AMENDMENTS TO THE DRAWINGS

REMARKS

By this Amendment, claims 7-8 and 10-12 are cancelled, claims 1-6, 9 and 13-17 are amended, and claims 18-21 is added. Thus, claims 1-6, 9 and 13-21 are active in the application. Reexamination and reconsideration of the application are respectfully requested.

FIG. 9A

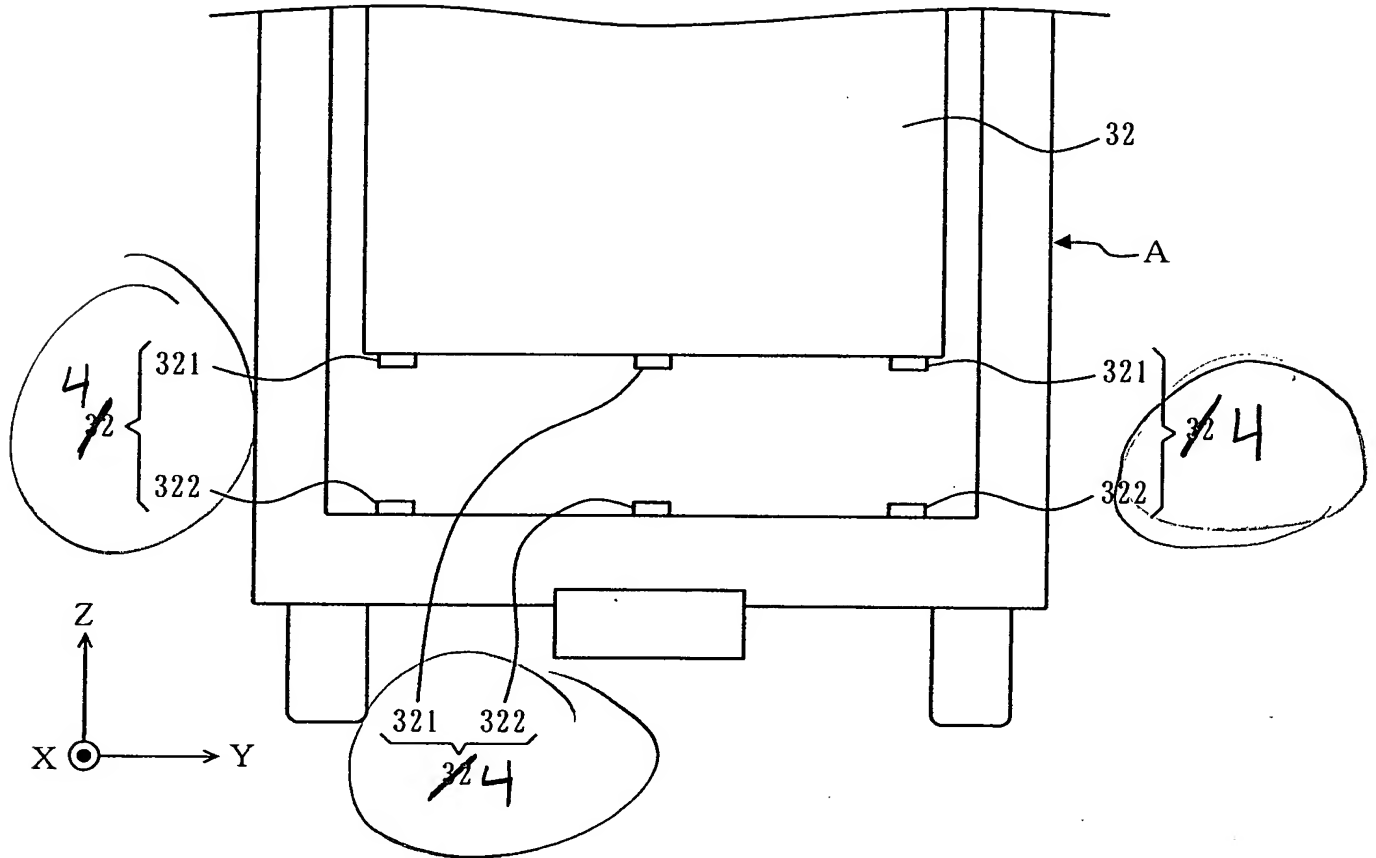
Replacement formal drawings of Figures 1-53 are submitted concurrently herewith under a separate cover letter in order to correct mislabeled reference numerals illustrated in Figures 9A, 9B, 16A, 16B, 17, 18, 19A, 19B, 38, 40-44, 45A, 45B and 48.

In particular, paragraphs [0060] and [0063] of the specification, for example, describe a fixing member 4 which includes pairs of magnets 321 and 322. However, Figures 9A and 9B illustrate the magnets 321 and 322 as being members of reference numeral 32, which is used in the specification and the drawings to denote the exterior screen of the exterior screen device 3 of the present invention. Accordingly, Figures 9A and 9B have each been revised to denote each pair of magnets 321 and 322 as being members of reference numeral 4 (the fixing member), instead of reference numeral 32.

FIG. 16A

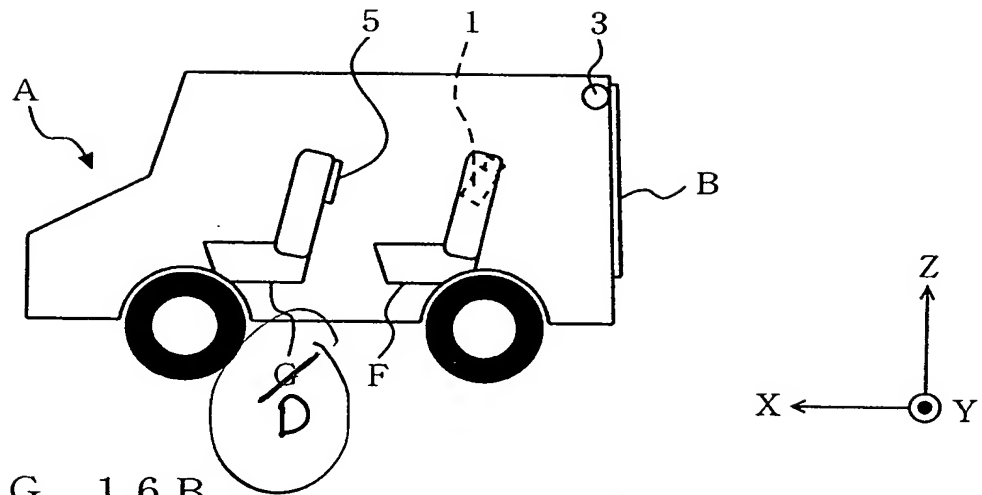
In addition, Figures 16A, 16B, 17, 18, 19A and 19B each illustrated the front seat of the vehicle A with reference numeral "G." However, reference numeral G is used in the specification and the drawings to denote the opening at the back door B or rear hatch B of the vehicle A. Furthermore, the specification describes the front seat of these drawings with reference numeral D, not reference numeral G. Accordingly, Figures 16A, 16B, 17, 18, 19A and 19B have each been revised to denote the front seat with reference numeral D, instead of reference numeral G.

FIG. 38

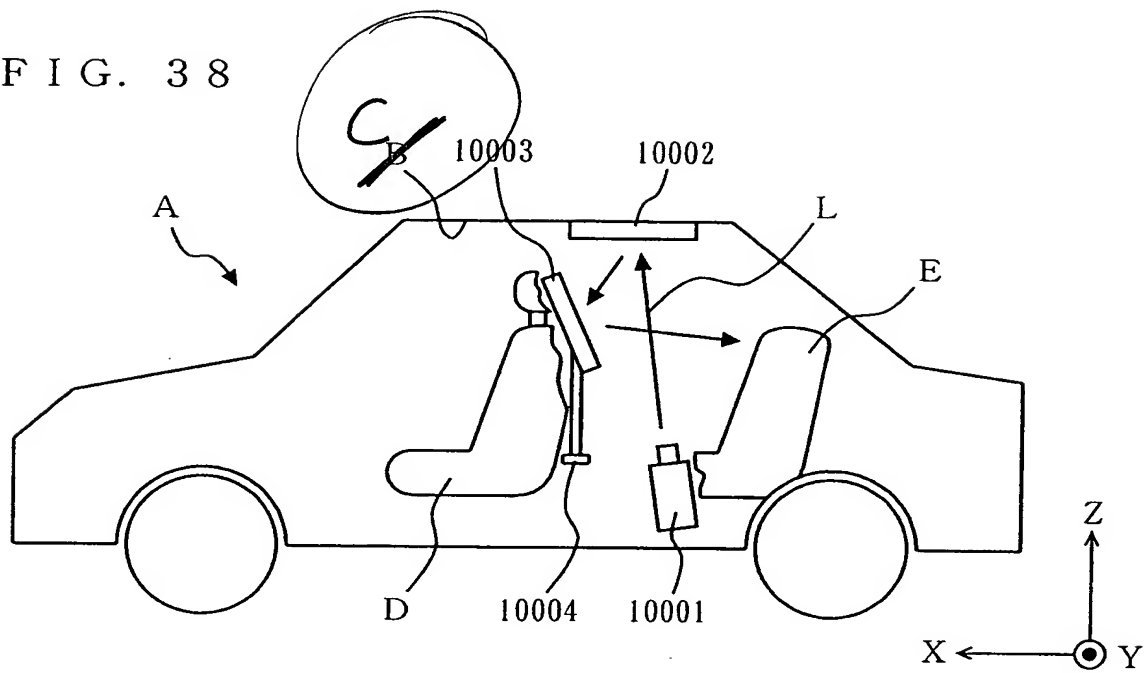
Furthermore, Figures 38, 40-44 and 48 each illustrated the ceiling of the vehicle A as corresponding to reference numeral "B." However, the ceiling of the vehicle A is

denoted with reference numeral "C" throughout the specification and in the drawings preceding Figures 38, 40-44 and 48. Accordingly, Figures 38, 40-44 and 48 have each been revised to denote the ceiling of the vehicle A with reference numeral C, instead of reference numeral B.

FIG. 43

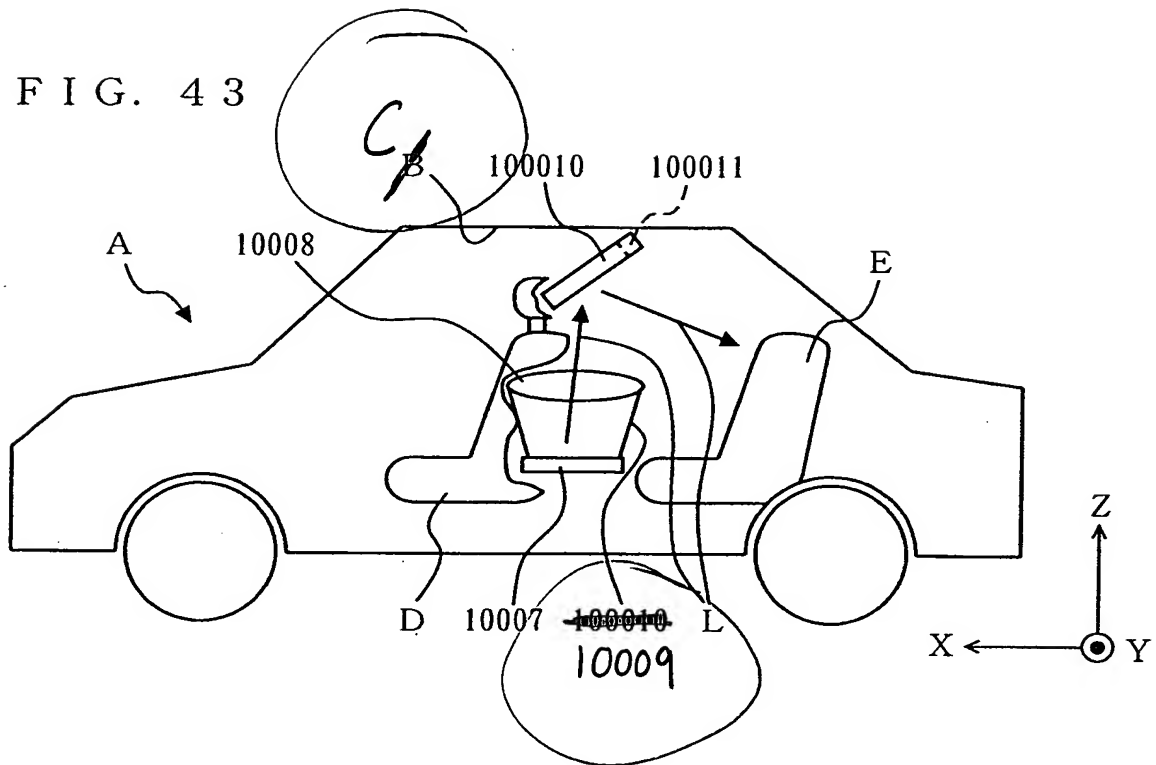
Moreover, the specification describes that display system illustrated in Figures 43, 44, 45A and 45B includes a first supporting member 10009 for supporting the lens 10008 and for covering the optical path for the light beam L emitted from the display device 10007 between the display device 10007 and the lens 10008. However, in Figures 43, 44, 45A and 45B, the first supporting member 10009 was incorrectly denoted with reference numeral 100010, which is also used to denote the reflecting member 100010 mounted near the ceiling C of the vehicle by means of the second supporting member 100011. Accordingly, Figures 43, 44, 45A and 45B have each been revised to denote the first supporting member with reference numeral 10009, instead of reference numeral 100010.
